SQA-8569 – Traffic Signal Supplementary Report

Name:	Cycle Enfield – A105 Corridor Scheme		
Type of Scheme	TfL Cycling Programme -Mini-Holland Scheme		
Borough	Enfield	Road Network (TLRN/SRN/Other):	SRN
Location and Scope of works:	<p>Significant modifications are proposed at the junctions listed in Section 5.2, with cycle facilities provided to improve safety for cycling. Where possible improvements have also been made to pedestrian facilities, whilst minimising the impact of general traffic and buses.</p>

Comments or additional supplementary information
<p>The design of the A1010 corridor as part of Enfield's Mini Holland scheme will provide improved facilities for cyclists travelling along the corridor. This will be achieved using segregated cycle tracks, Toucan crossings, and providing priority for cyclists at signalised junction using Low Level Cycle Signals. All sites are to be upgraded to 21C UTC and have SCOOT added.</p> <p>For all sites the data provided was a Preliminary design drawing (1:200), accident statistics for the corridor, a proposed Linsig model and a Technical note. Traffic counts have been provided as part of the model audit process. 85th percentile speeds h

32/053 A1010 Fore St by Bridge Rd Pedestrian Crossing

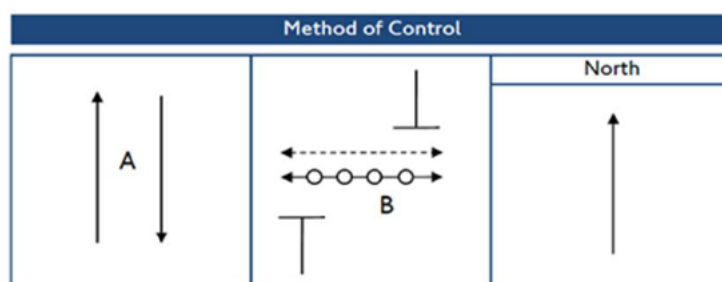
The scheme proposes to make changes to the existing signalised Toucan crossing which is to be retained with modifications at the northern and southern approaches of this junction to provide an improved layout for the cyclist movements.

32/111- Hertford Road - Edmonton Green - Balham Road

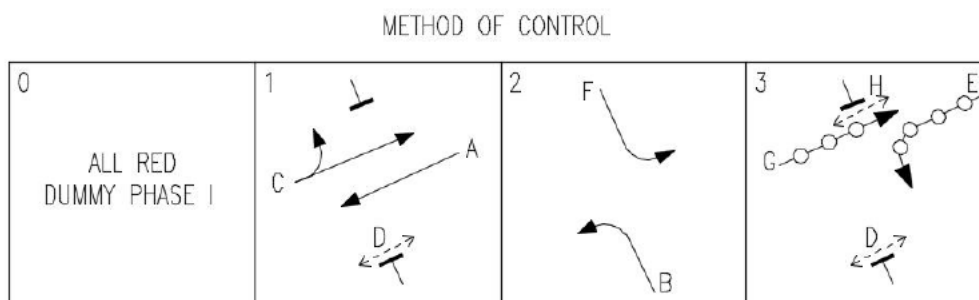
This junction is to be modernised and the layout will be changing. The main changes are the staggered crossing is to be removed and the crossing point moved toward the new roundabout. The crossing is becoming a straight across crossing in two parts with PC@Ts. Another change to the layout is the new lane for westbound cyclists, which crosses both carriageways. Balham road is now to be signalised, with pedestrian facilities and PC@Ts. There is SCOOT currently on site but will need to be adjusted to for the new layout, it is to be retained. There is also an eastbound segregated on carriageway cycle lane which leads to the bi-directional off carriageway cycle track. PC@Ts will also be provided for the crossing exiting the bus station.

32/195- A1010 Hertford Road - Edmonton Green Bus Station Northern Junction

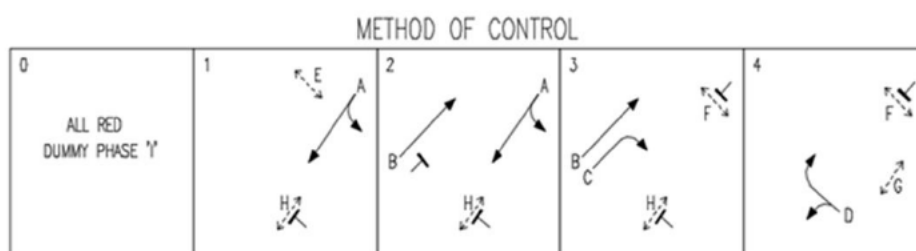
There are no changes to the junction in terms of signal works but there will be major changes to the layout as there will be an addition of a bi-directional cycle track on the northern footway. There will also be a removal of a northbound ASL and a non signalised stopline. Existing SCOOT is to be retained.

32/231 – Edmonton Green Roundabout – Church Street – The Green – The Broadway

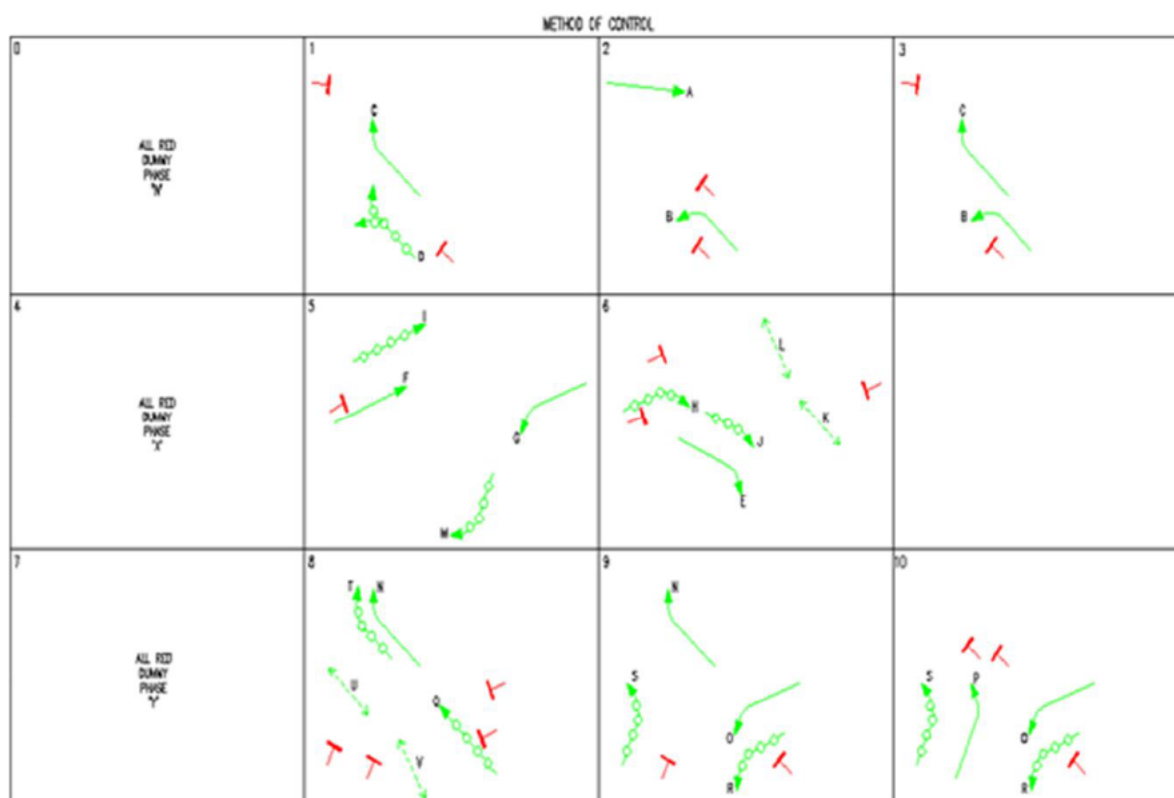
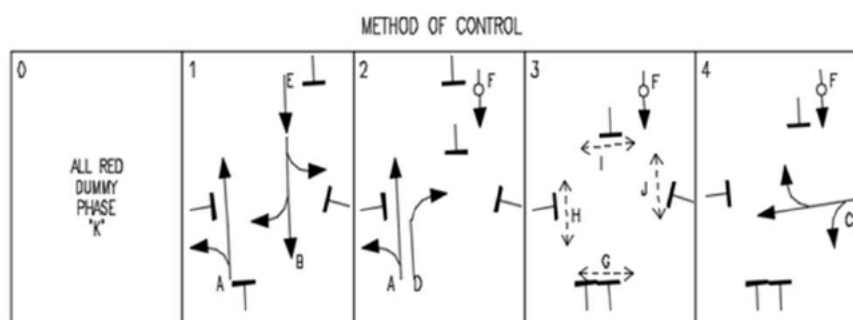
This is a new site which will significantly alter the roundabout's current layout. The introduction of multiple islands and cycle lanes will significantly reduce the roundabouts existing capacity, reducing it to a single circulatory lane. These islands will be used to provide segregated cycle facilities on all entries and exits from the gyratory. Cycle signals will also be provided on the circulatory at all potential conflict points with vehicular traffic. The roundabout is to have multiple cycle stop lines which will potentially hinder cyclist progression and may lead to non-compliance to the cycle signals causing them to exit segregation in order to progress. The roundabout proposal is to utilise signals on each of the three arms of the gyratory. These will run as separate streams.

The first stream is on the Church Street arm of the junction and includes vehicular and cycle movements. This is the only arm that provides no pedestrian facilities as there is a separate existing pedestrian crossing in close proximity to the roundabout, under the bridge. This crossing has a significant amount of bird excrement on it and has previously been raised as a health and safety concern to Enfield council. There will need to be some mitigation put in place as part of this project. There is also concern with left turning traffic exiting the roundabout on the first and third streams. Traffic can pass the left turn stopline in the right hand lane on the circulatory and then turn left exiting the roundabout past the stopline potentially without visibility of the signals and pass through cycle and pedestrian movements uncontrolled. Jacobs have stated that they intend to mitigate this issue with the use of wands to provide the necessary segregation and deter incorrect use of the exiting traffic.

The second stream on the roundabout is the northern intersection with The Green. This stream also has vehicular and cycle movements as well as a staggered pedestrian crossing. This is a straight over staggered pedestrian crossing which does not meet TfL's current standards as there is a 5 metre internal clearance rather than the required 7 metres. This risk has been mitigated by the MOC being restricted so that both phases of the staggered crossing will start and terminate together, acting as one crossing. This will mean that the risk of see through is eliminated. Buses will exit the second stream and enter the bus terminus. This un-signalised left hook has a dedicated cycle stopline and signals to ensure there is no conflict with cyclists on the circulatory. The third stream is the southern junction with The Broadway. This arm is much the same as the second stream, with a sub standard straight over staggered crossing. All of the proposed crossing points are to have PC@T facilities provided. The site is to have a maintenance bay within the roundabout which will have immediate access to the junction controller and a secondary ESP. The site will operate under UTC SCOOT to allow for the optimisation of the signal timings.

The site is in the middle of Edmonton Green tube station, bus terminus and shopping centre. Works on this site will cause significant disruption.

32/018 Hertford Road / Bounces Road / Croyland Road

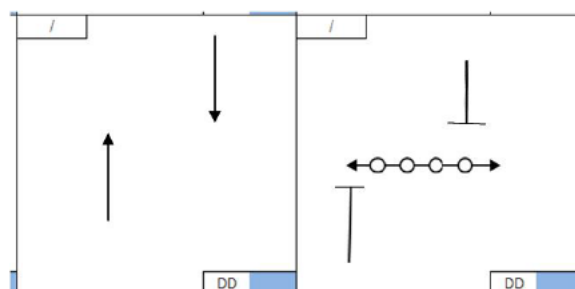
The need for safety and priority for cyclists' progression through the junction of A1010 Hertford Road/Croyland Road/Bounces Road has resulted in the junction modification.

Croyland Road will be converted to one-way eastbound (EB) between the junction of Hertford Road and Millbank Road. The restricted inbound movements from Croyland Road will be diverted via Bury Street to access the A1010 corridor

The SB approach to the junction is proposed to be converted from two lanes to single lane approach to accommodate the southbound cycle lane.

The SB right turning movements from the A1010 to Croyland Road is to be banned. This will provide additional capacity by not blocking the straight-ahead traffic movements. This change in the junction operation will also improve the safety of NB vehicles turning right at the junction, which will no longer be opposed to the SB right turn movement.

On the SB approach, there is a cycle gate with 18m storage, to be fed from a segregated nearside cycle lane.

On the NB approach, an advanced stop line (ASL) is provided with 7.5m storage fed by nearside mandatory cycle lane, this approach will have a 4 sec early release for cyclists.

Due to the presence of the ASL and storage on the NB approach of the junction, the exit-only gate of the petrol filling station located at the south-east corner of the junction is to be restricted to left turning movements only

The width of the pedestrian crossing facilities across Hertford Road will be widened to 4.0m.

An advanced stop line (ASL) facility with 5m storage is provided at the Bounces Road.

32/230 Hereford Road/Bury Street/Rosemary Avenue

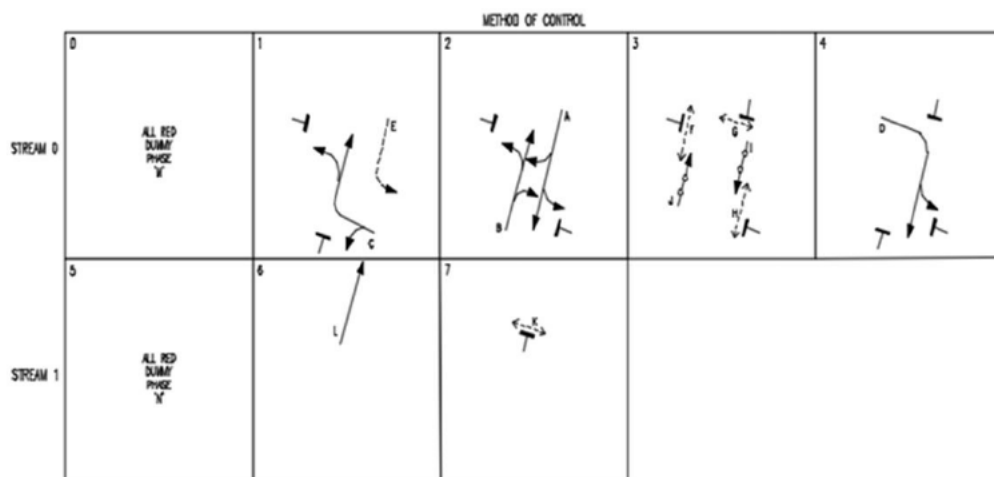
The scheme proposed to introduce a new signalised junction to replace the existing mini-roundabout. A segregated cycle lane will be built and run north controlled by its own dedicated cycle signal. Also, cycle holding areas will be created a signalised to allow cyclists to be ahead of general traffic at specific conflict points at the junction. This proposed design is too predominantly to mitigate the potential left turn hook conflicts between general traffic and ahead cyclists.
